ADDENDUM NO. 4:

Date: February 13, 2026
 Project: Verbena HS Gym
 DCM# 2025629
 WSM# 25-032

Owner: Chilton County Board of Education
 Architect: Ward Scott Morris Architecture, Inc.

PROJECT: Verbena HS Gym	ENG #2559 ARCH #25-032 DCM #2025629	DATE: February 13, 2026
-----------------------------------	---	-----------------------------------

BID DOCUMENTS		
DATE: 01/08/26 PROJ NO: 25-032		
REVISIONS		
#	DESC	DATE
1	ADD 004	02/13/26
SANITARY PLAN		
P101

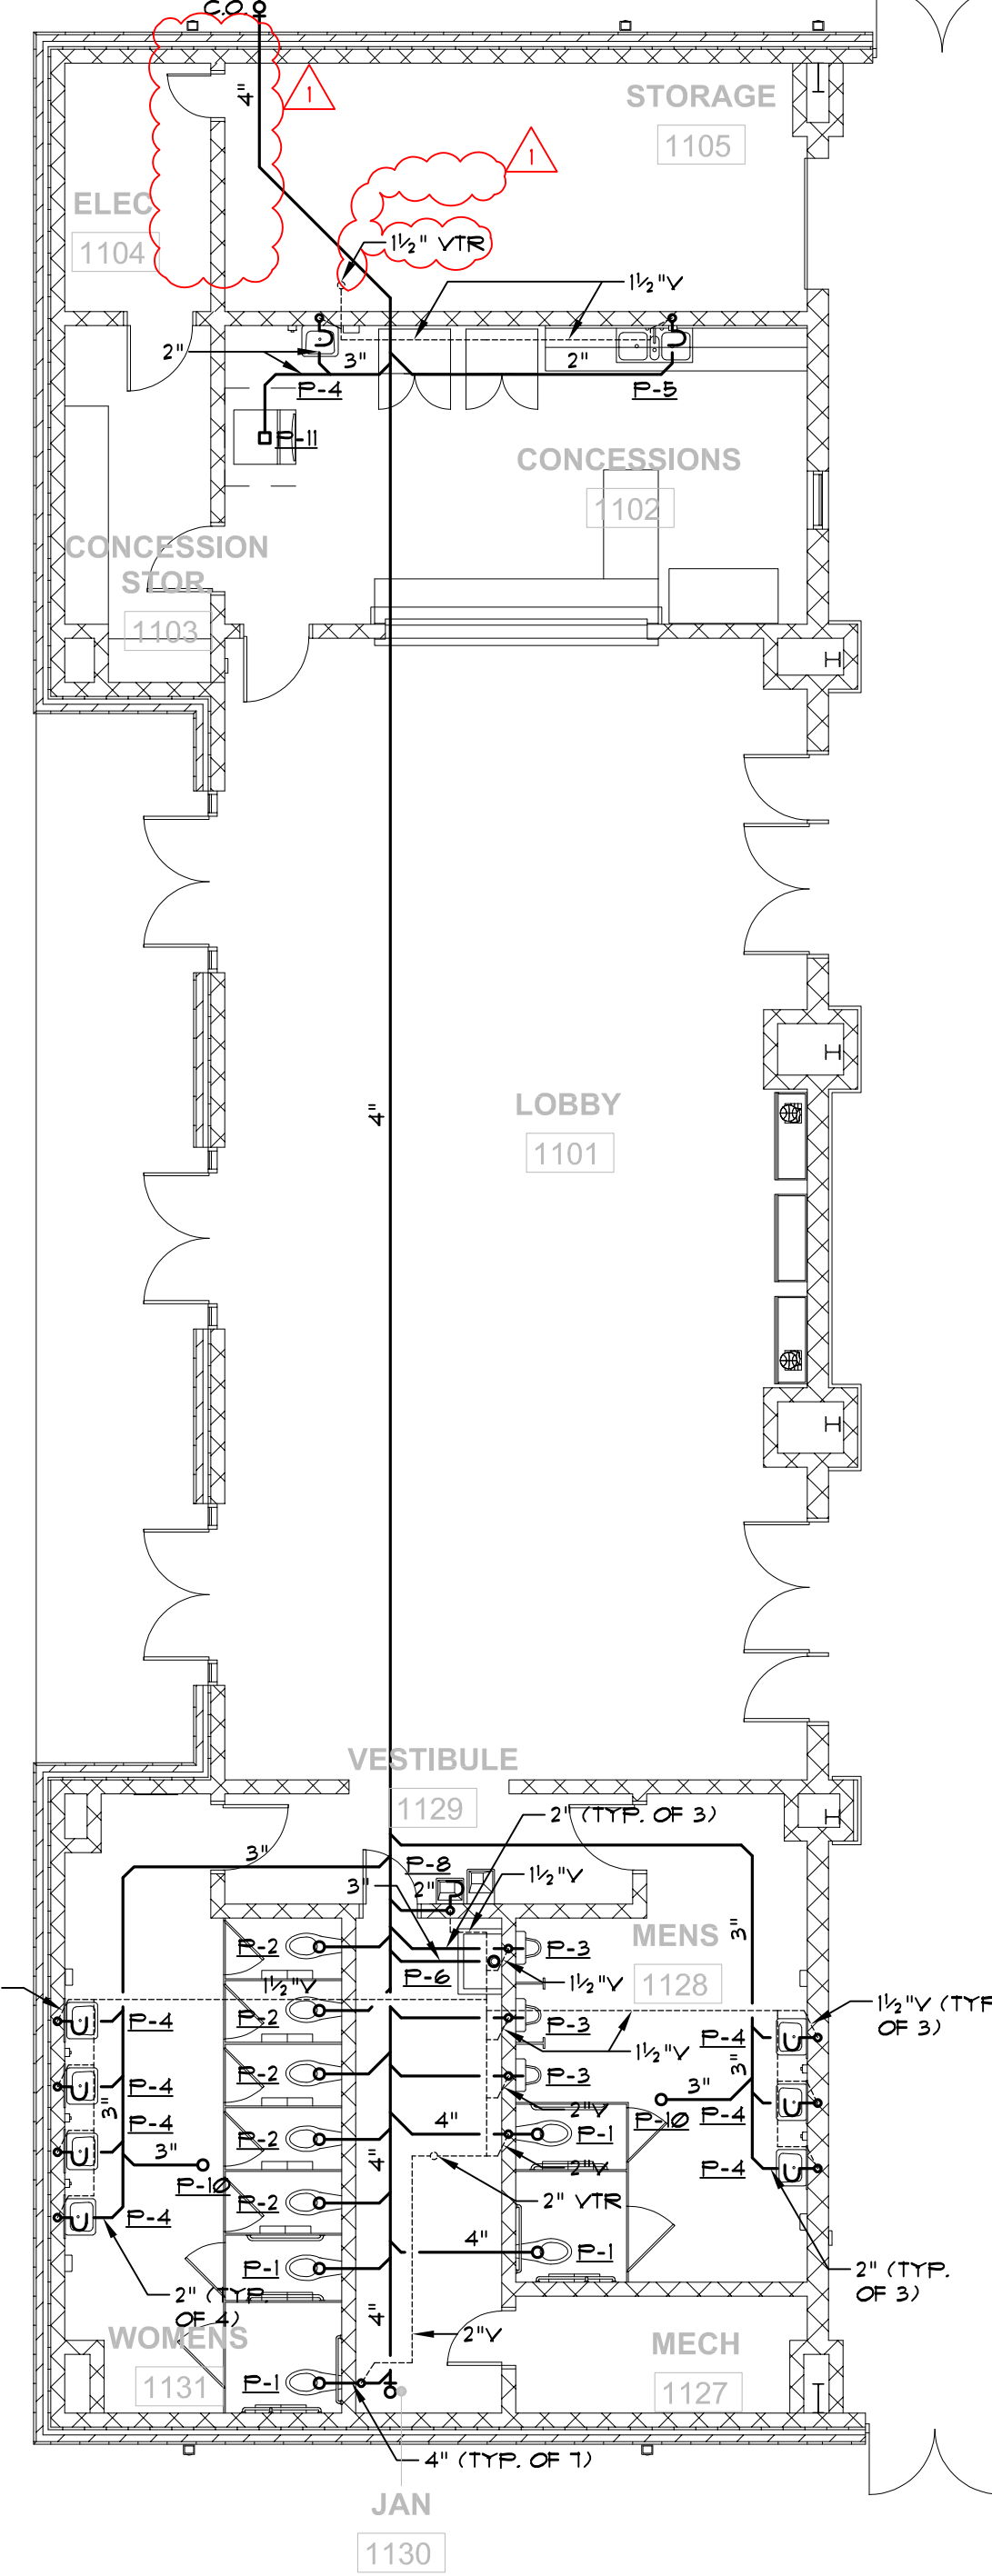
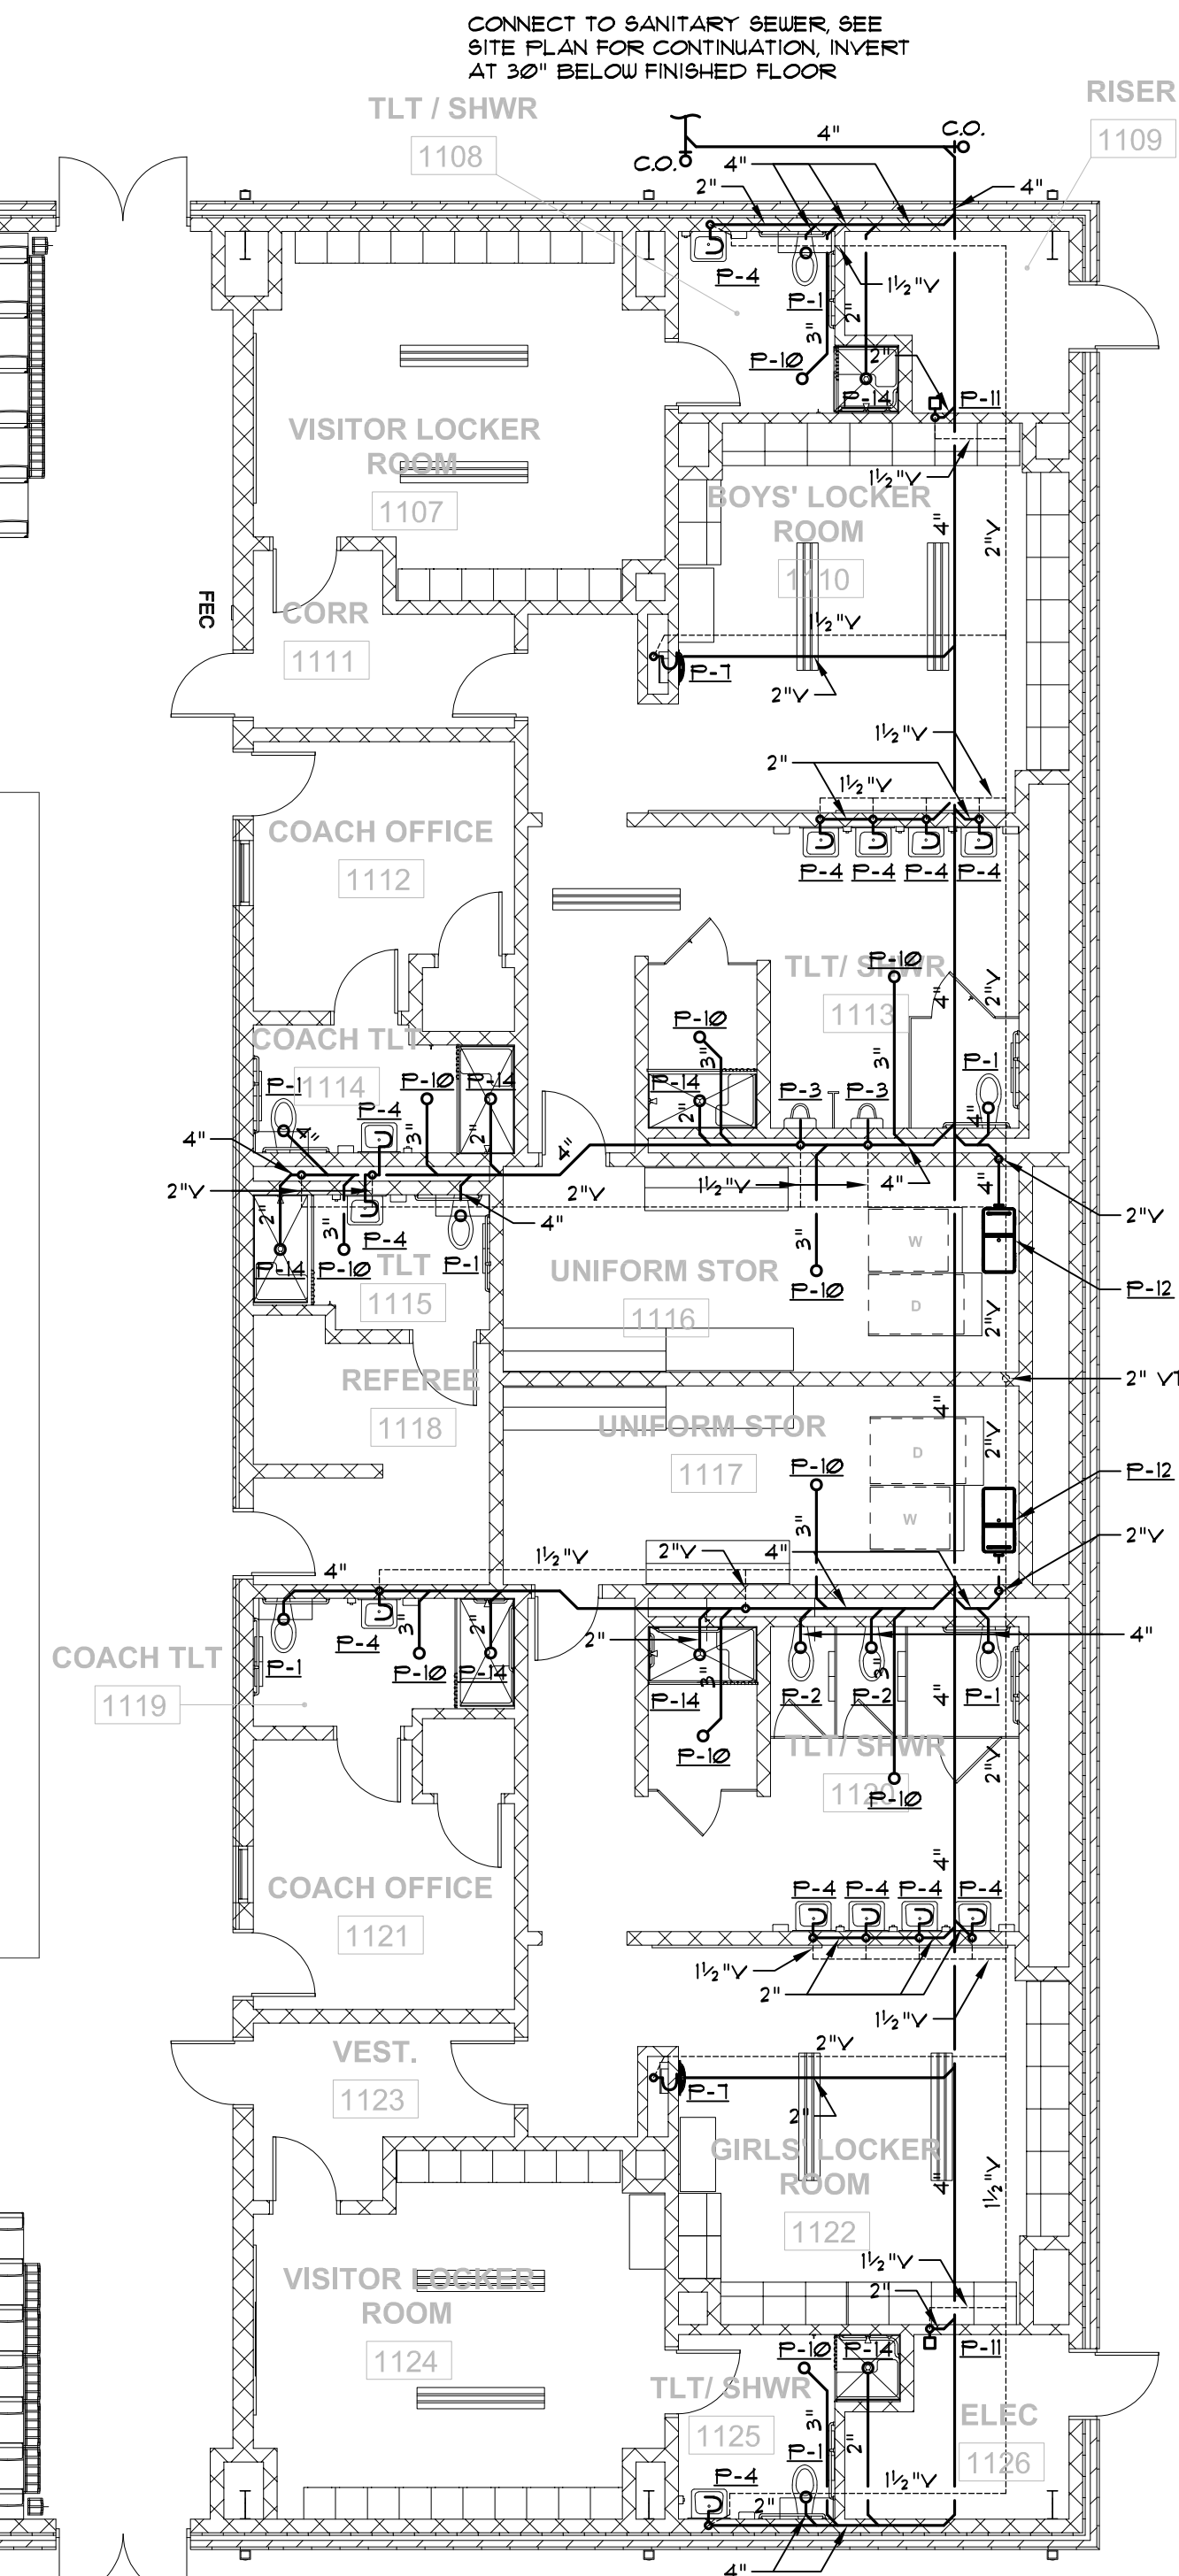
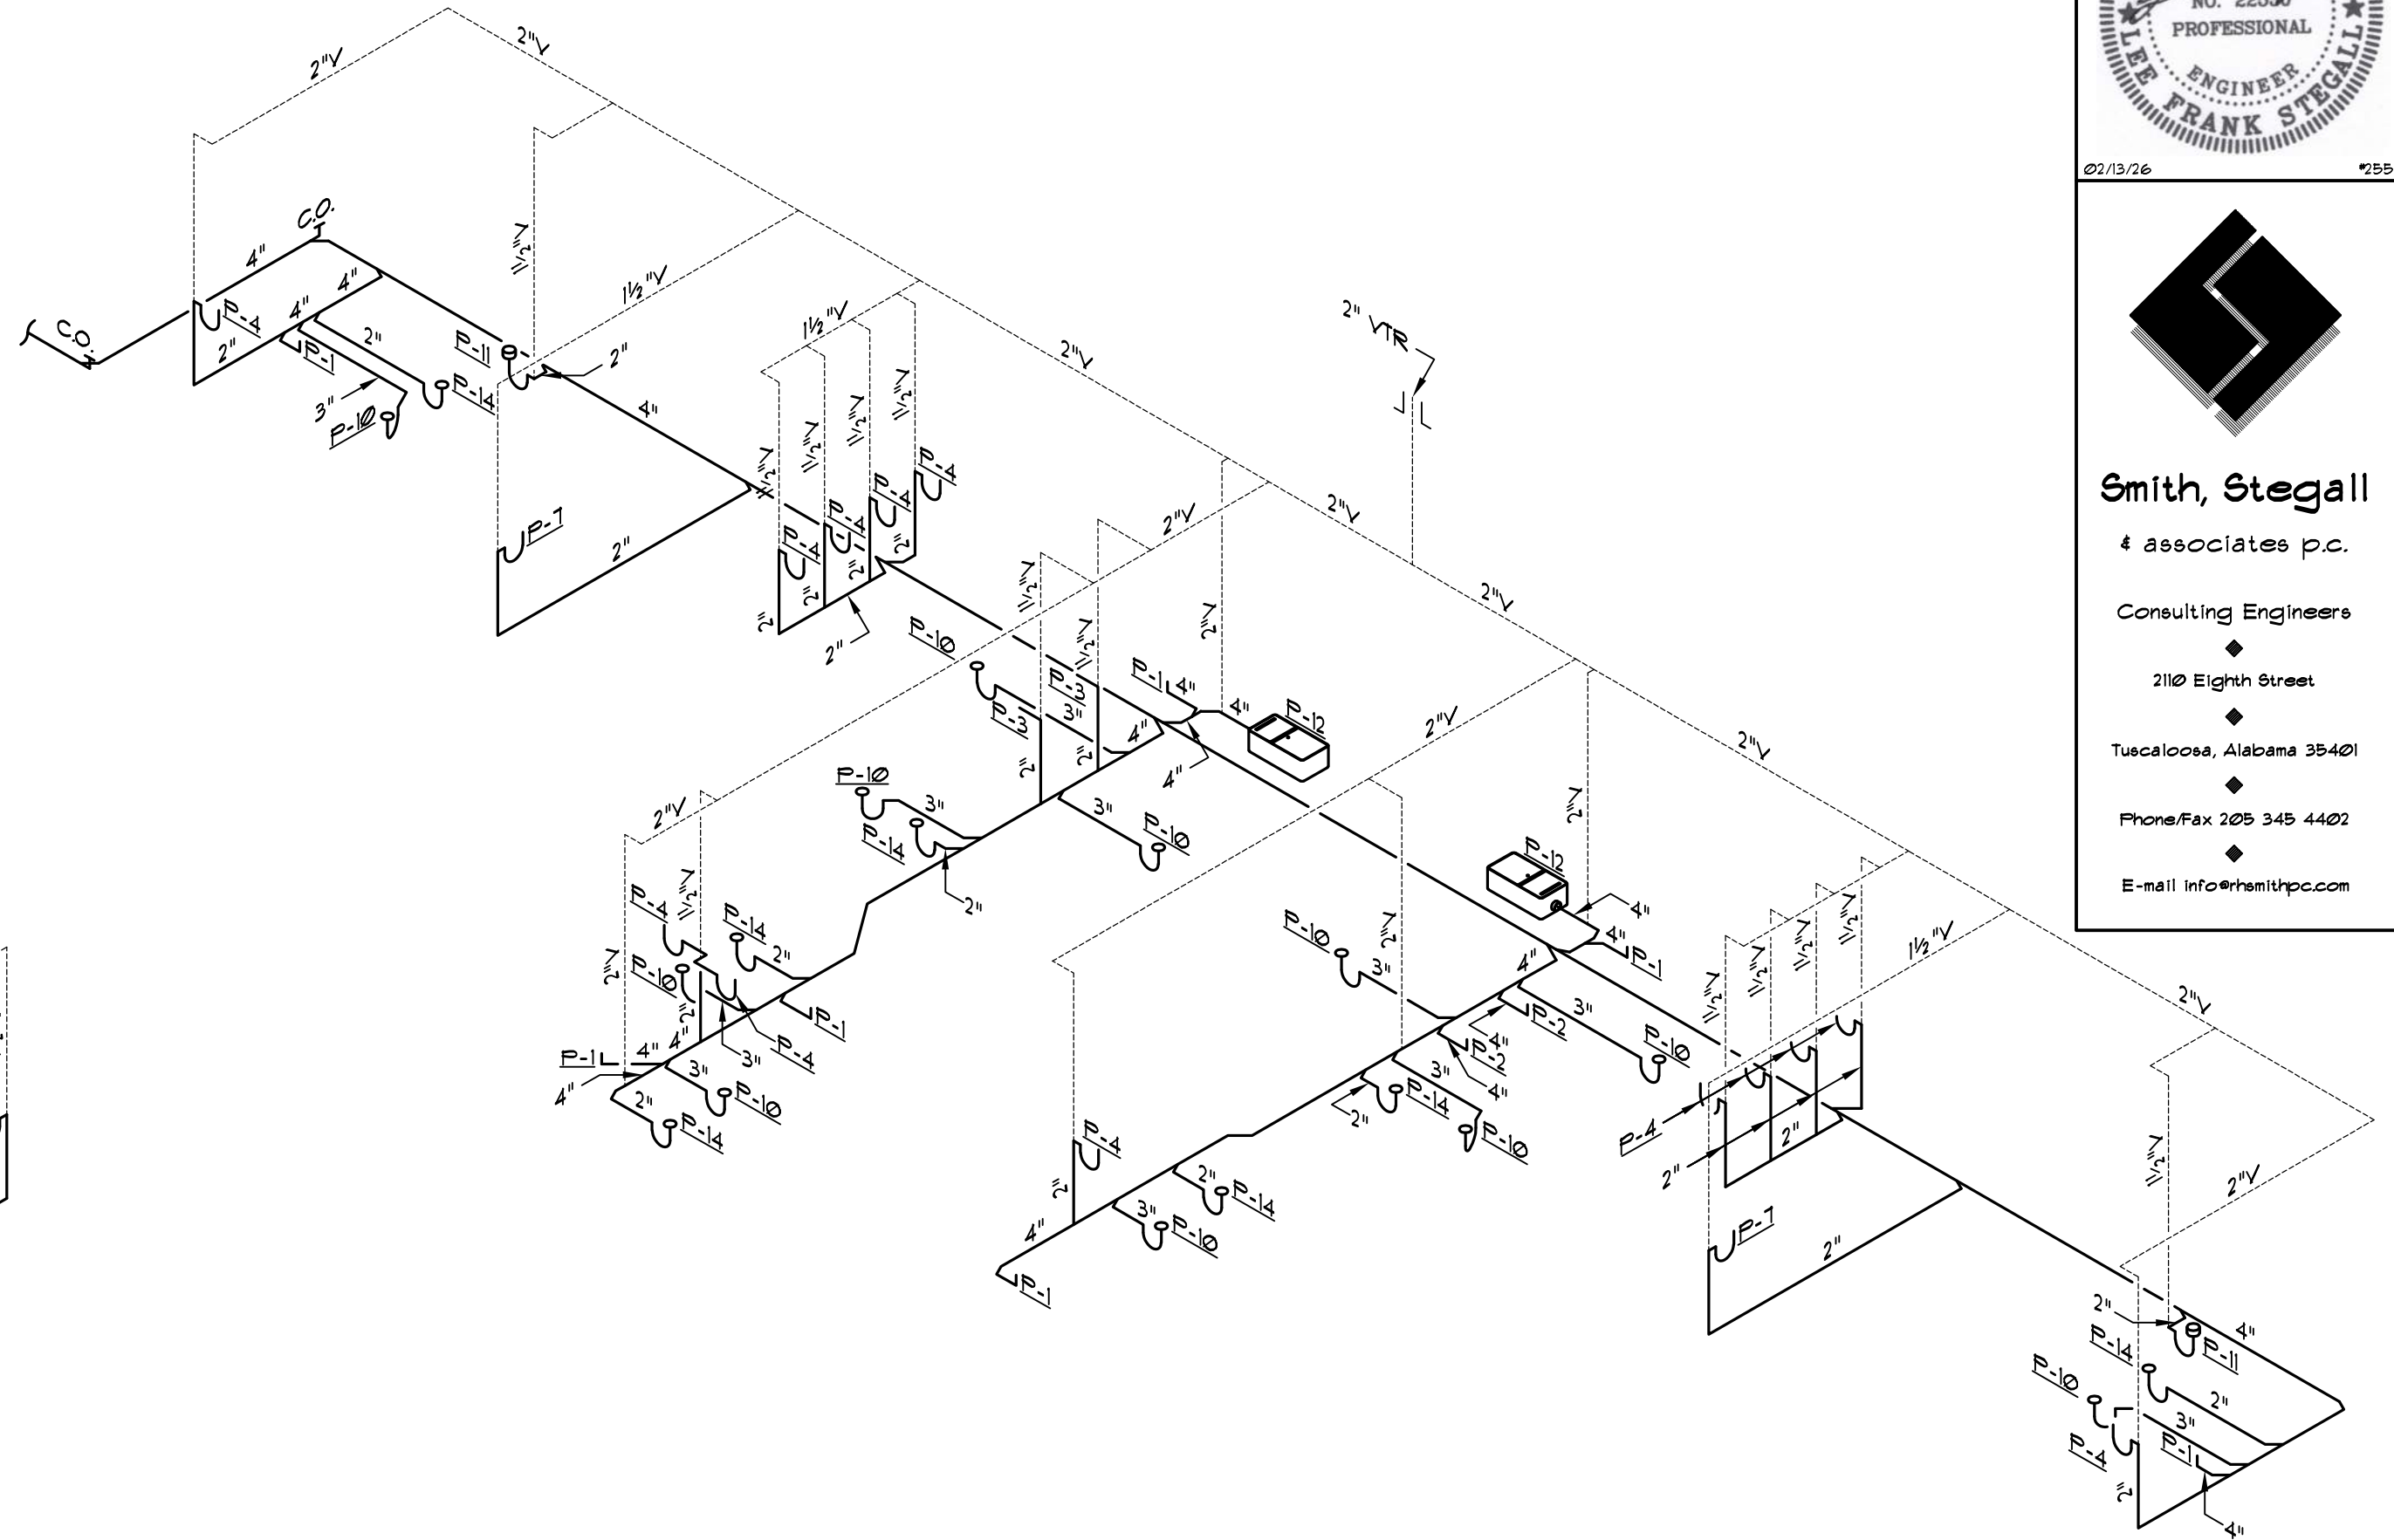
1. Sheet P001: P-17 is recirculating pump for domestic water.
2. Sheet P101: Delete floor drain in former fire pump room.
3. Sheet P201: Delete pressure boosting pump. New water service to area provides 75 PSI.
4. Sheet P201: Relocate water service to Riser 1109
